COST ITEMIZATION									
PCO NO.	31	AMFRICAN DE							
PROJECT:	Williamson County Sheriff's Office Trai	ning Center	AMERICAN CONSTRUCTORS						
CONSTR. MGR.:	American Constructors, Inc.								
DOCUMENT NAME:	PR 012		DATE:	09/08/17					
SUBJECT:	PR 012 Toilet Accessories								
Extended Calendar Day	ys Requested:	Funding Source	CM Contingency						
	ITEMIZED COST BREAK	DOWN							
	Separate line for each item								
Sub Name	Work Description	FIRM	ESTIMATED	TOTAL					
Slater	PR 012 Toilet Access	\$4,336.00		\$4,336.00

PROPOSAL REQUEST

Williamson County Sheriff's Office Training Center

PROPOSAL REQUEST NO:

Sheet A270 - Modify locations as indicated.

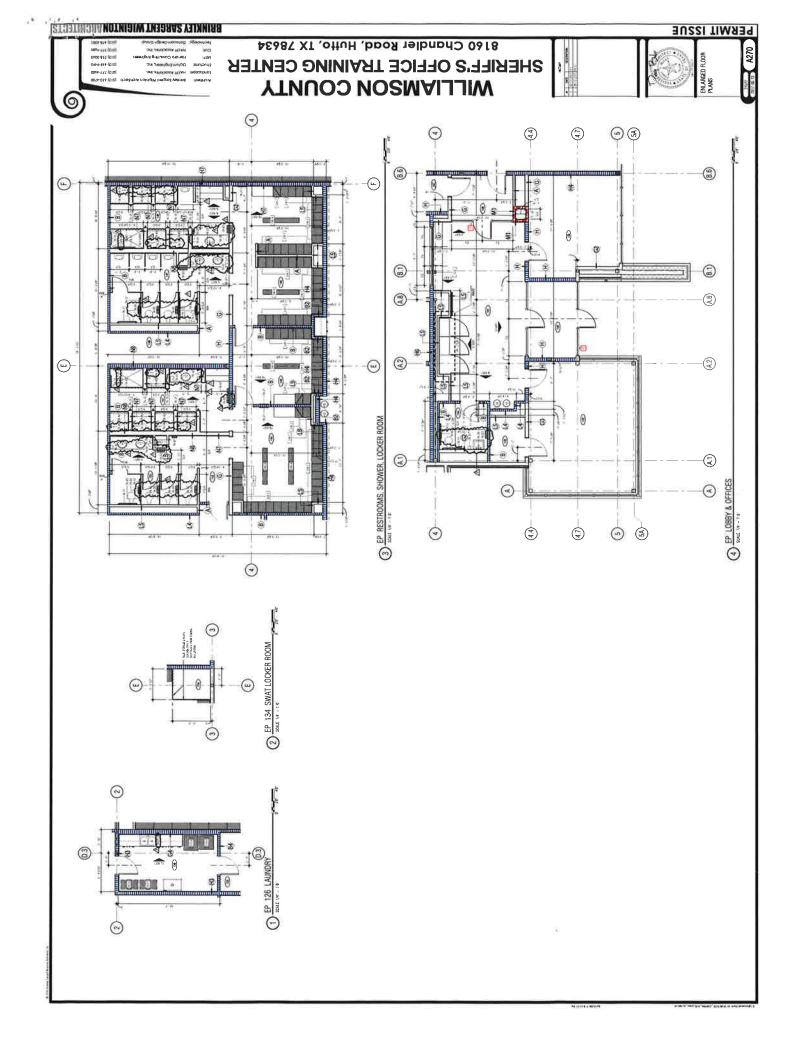
Description: Incorporate the following revisions to the documents to change the indicated toilet accessories to OFCI as requested by the Owner.
